Sumter City-County Planning Commission

February 23, 2011

PD-11-01, 2825 Carter Rd. – Covenant Place (City)

Request: Rezone PUD-96-09 to PD-11-01 to add additional detached single-family and duplex residential uses, life enrichment center, storage facilities, additional site access, and recreational open space to the existing Covenant Place retirement community site.

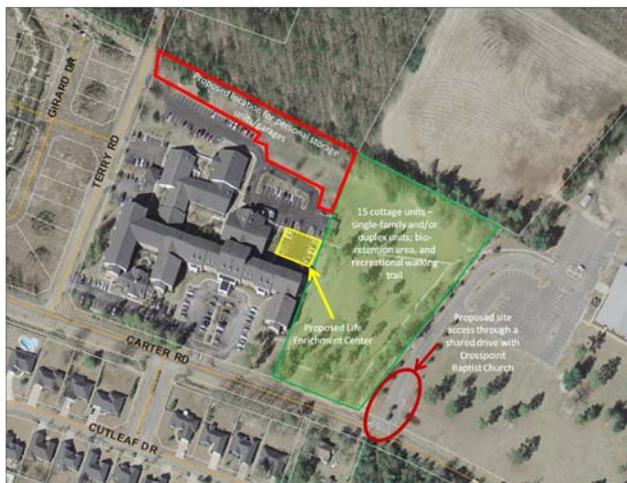
As shown in the graphic on the left, the current request will effect three parts of the property, allowing the development of a single-family detached and/or duplex style residential subdivision on the eastern portion of the existing parcel; the provision of a Life Enrichment Center; and new storage units for independent

living residents. The newest area of development will be accessed from the Crosspoint Baptist Church driveway through a shared access agreement in the area indicated by the red oval.

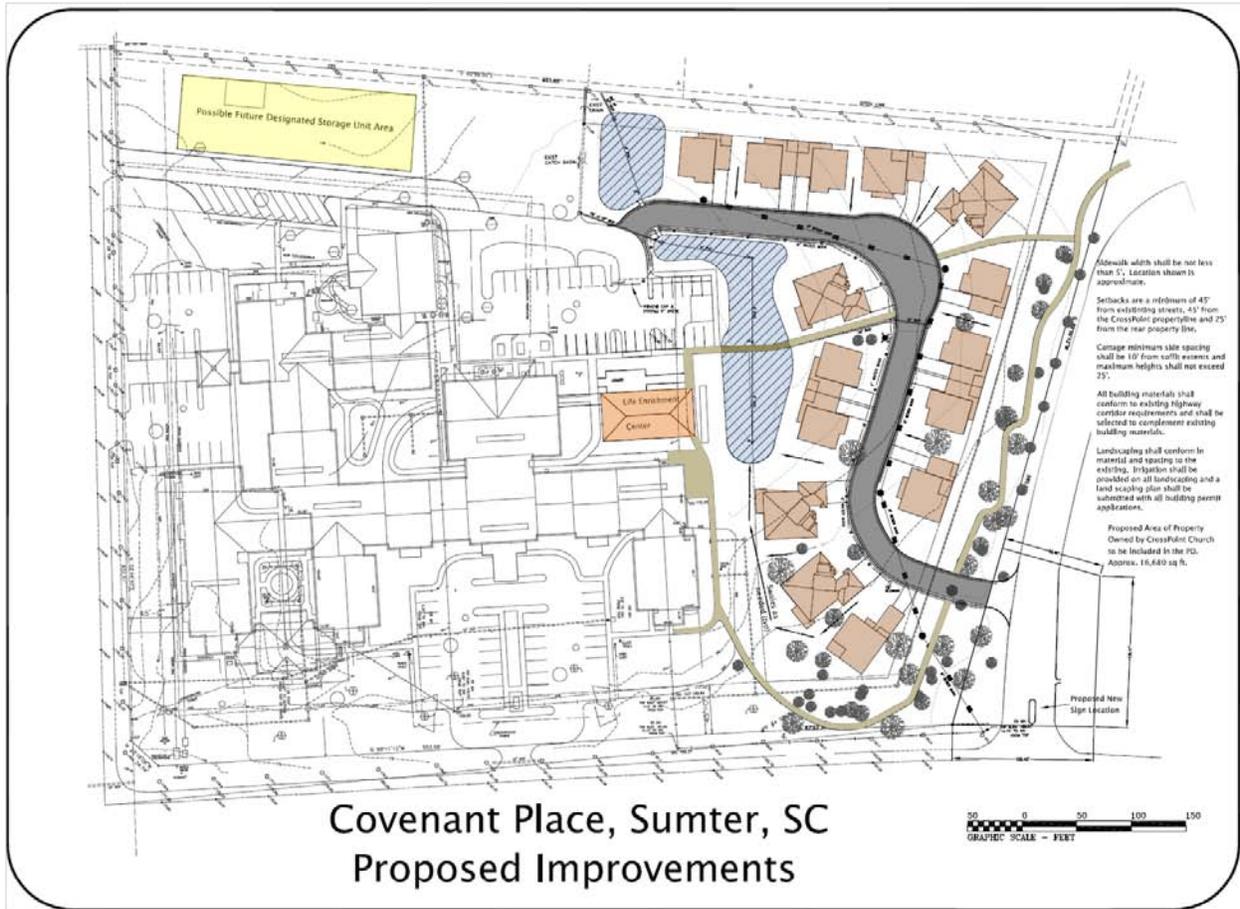
- 15 residential units – detached and duplex (shown in brown)
 - Accessed by private road from a shared common drive with Crosspoint Baptist Church
 - Each unit to have individual driveway and 1 or 2 car garage
- Proposed Life Enrichment Center to be used by entire Covenant Place Community (shown in orange)
- Area reserved for personal storage units to be used by independent living units (identified in yellow)
- Open space to be accommodated through tree preservation and implementation of a walking trail that loops through the neighborhood and connects to the Crosspoint Baptist Church sidewalk.
- Stormwater is to be managed through LID principles including bio-retention beds (approximate location shown in blue) which will be implemented into the open space plan.

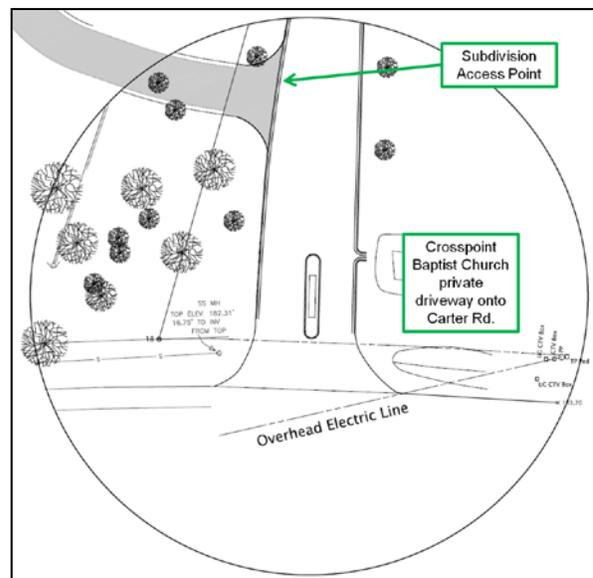
As shown to the right, the proposed access point for the subdivision portion of the property—Covenant Place Village—will be from the existing Crosspoint Baptist Church entrance drive. There will be no direct access to Carter Rd. from the subdivision. The secondary access

for the subdivision will be from within the Covenant Place parking lot at the rear of the parcel. Overall site design has taken measures to reduce new sources of conflict on the Carter Rd. corridor. The shared access configuration reduces the number of curb cuts on Carter Rd. thereby reducing conflict points on the existing road network. 15 single-family units at this location are expected to add approximately 150 average weekday trips to the adjacent road network and are not anticipated to degrade the existing levels of service.
